COUNTY OF EL DORADO

DEPARTMENT OF TRANSPORTATION

SUBJECT: Responses to Bidders' Inquiries No. 3
El Dorado Trail Improvement Project, Forni Road to Missouri Flat Road
(Bid No. GS 08-1021)

Bid Inquiry No. 3 contains responses to questions posed for the above referenced project.

PLAN VIEW OF RAIL/POST CONNECTION
 NO SCALE

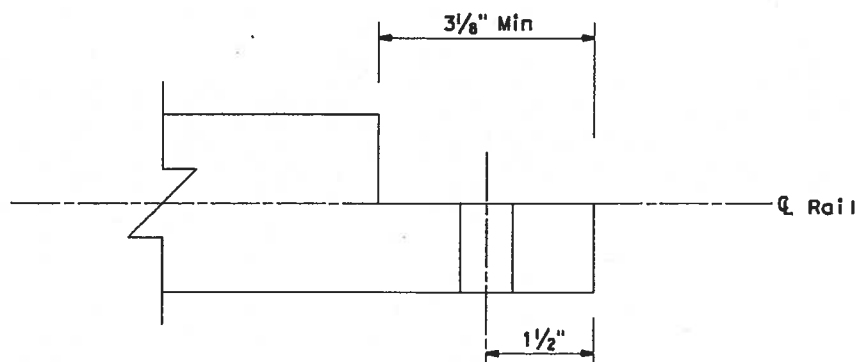
3.08	Plan Sheet C19	<p>Question: The revised retaining wall detail in addendum #2 shows timber treated railing being constructed on top of the Retaining walls. What bid item do we bid this on, and are the quantities going to be adjusted to make up for that added treated timber on the retaining walls.</p> <p>Answer: The limits and quantity of treated timber railing are unchanged. The retaining wall detail in Addendum 2.21 was provided to clarify the connection of the treated timber railing to the retaining wall.</p>
